**REVISION:** A

**AIRCRAFT MODEL:** Husky A-1, A-1A, A-1B, A-1C 180 and A-1C 200

**SUBJECT:** Threaded Tie Rod

Model Number \_\_\_\_\_ in accordance with Service Bulletin No. 26.

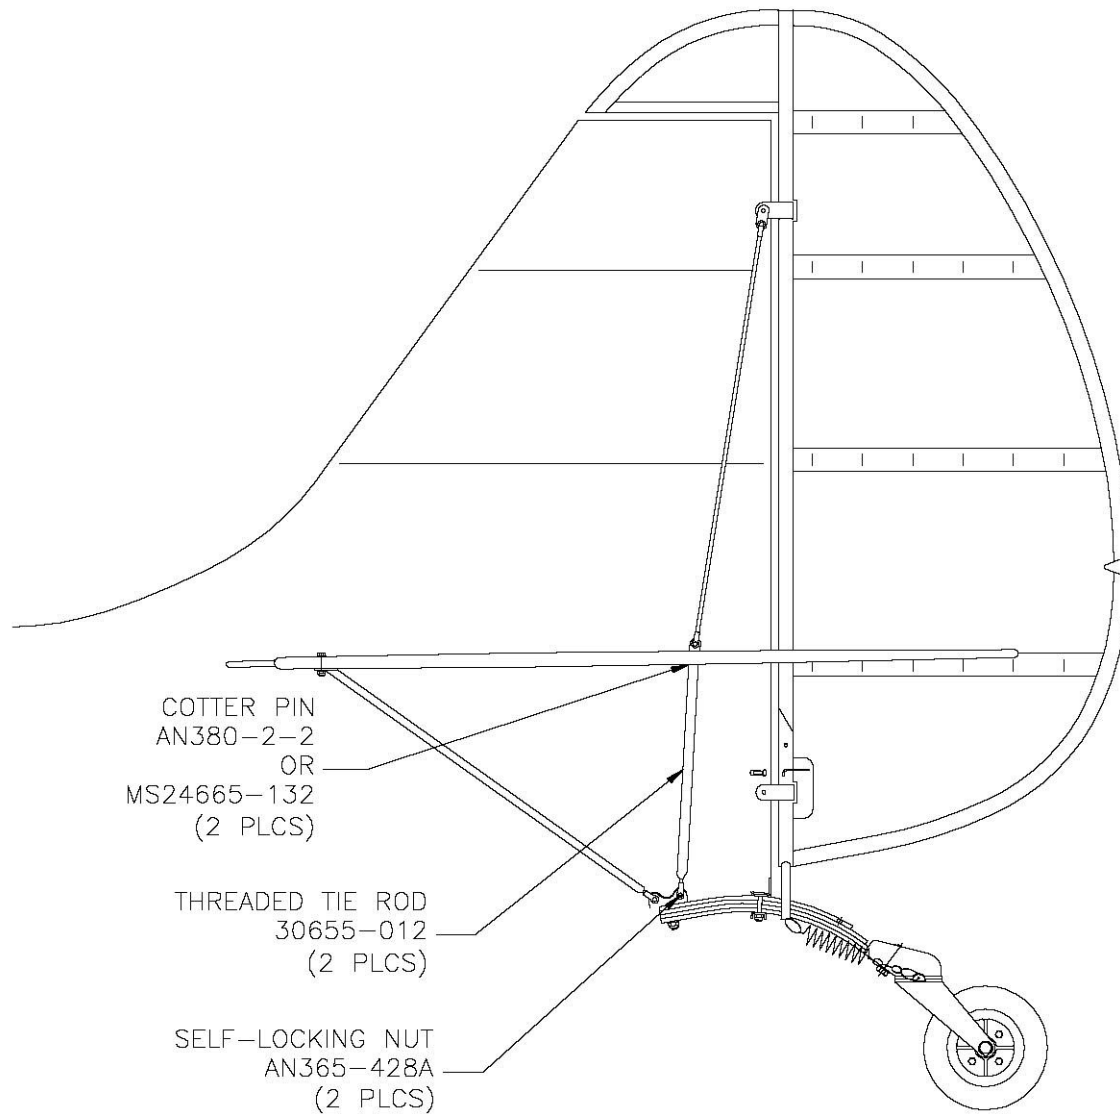
As stated in POH prior to any flight operation, the Husky should receive a thorough inspection. During such inspection if it is concluded that the threaded tie rods are in a worn condition, replace such tie rods with rolled threads instead of cut threads. The rolled thread tie rod should minimize failure of the tie rod.

It is requested that both ends of each threaded tie rod be visually inspected before each flight for any cracks in the threaded portion of the strut fitting where tie rod screws into the terminal end.

If during inspection cracks are found purchase new threaded tie rods from Aviat Aircraft Inc. Part number for the threaded tie rod is 30655-012. Replace threaded tie rods using appropriate F.A.A. authorized mechanics. Complete and send compliance letter to appropriate addresses.

1. Loosen top nut on rudder fuselage to relieve tension.
2. Remove lower nut at horizontal stabilizer/elevator attach point.
3. Remove nut and bolt that attached threaded tie rod to strut attach bracket.

4. Remove threaded tie rod.
5. Pull cotter key from end of threaded tie rod assembly.
6. Measure center hole to center hole from clevis to determine length of threaded tie rod.

7. Reverse process to install new threaded tie rod. Replace provided hardware.
8. Remove rear cushion seat. Place smart level on forward horizontal rear seat tube to determine level or 0°.

9. Place level on trailing edge between the two center ribs to check for 0° on stabilizer. If adjustments are needed turn threaded tie rod in appropriate direction to accomplish 0° then tighten jam nut and front locking nut.

10. Check witness holes on clevis to determine appropriate thread depth is acquired.
11. Loosen jam nut and adjust as needed forward stabilizer strut to keep front of stabilizer level.

12. Check wire tension of top tail wires. Tension should be between 100-125 lbs. Using tensiometer.
